Technical Memorandum

Re: Canterbury Independent Senior Living Permit Amendment (LMRWD No.

2021-040)

<u>Project Name</u>: Canterbury Independent Senior Living

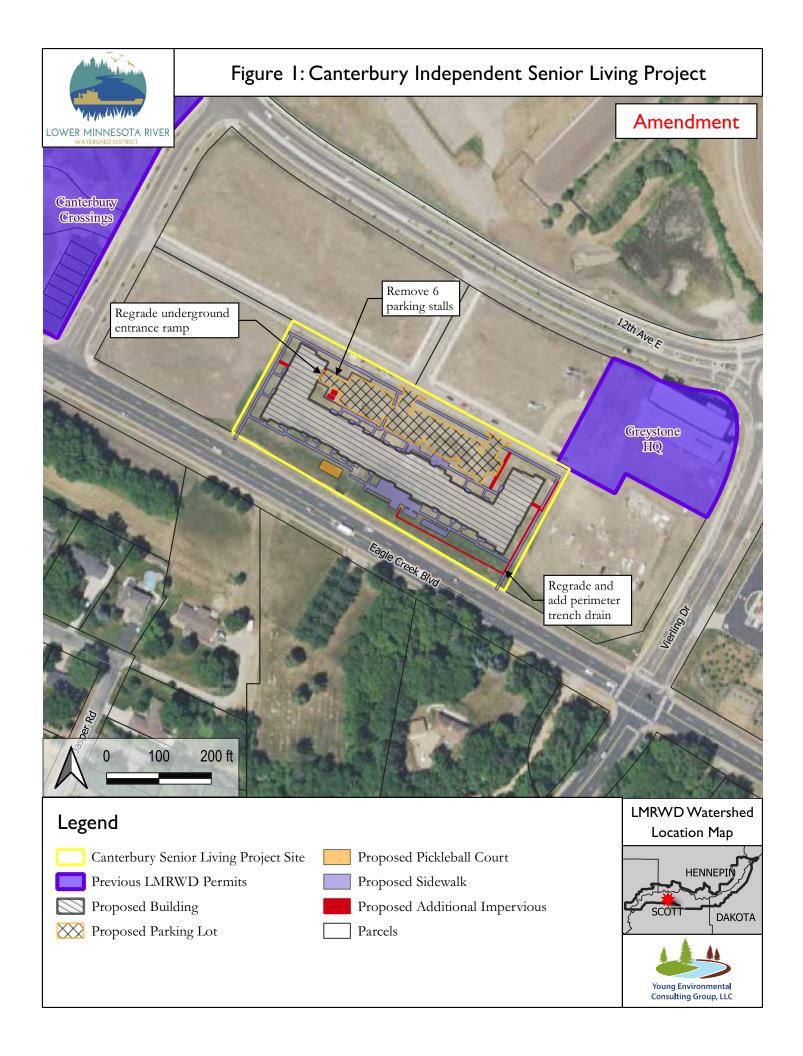
The proposed new impervious area will be increased from 2.0 acres to 2.06 acres on a 3.5-acre parcel, as shown in Figure 1. The proposed design changes include the following:

- Removing six stalls from the parking lot to regrade the underground parking entrance ramp and minimize drainage to the ramp trench drains
- Regrading the southeast perimeter of the building and adding a concrete perimeter trench drain to meet the minimum emergency overflow requirements of the City

The redesign does not affect the stormwater treatment plan or the overall drainage pattern. Stormwater will continue to discharge directly into the existing City stormwater infrastructure, which is then treated by Pond 03P, the Canterbury Park Infield Ponds, and Northwest Pond (Figure 2). These ponds were previously constructed and now are part of the City's MS4 program. The Project is within the Plan's 03.2S sub-watershed (Figure 2), which allows a maximum of 80 percent impervious area at each development. While the redesign proposes to increase the impervious area percentage from 57 percent to 59 percent, that figure remains below the maximum impervious area threshold. Therefore, the Project remains in compliance with Rule D.
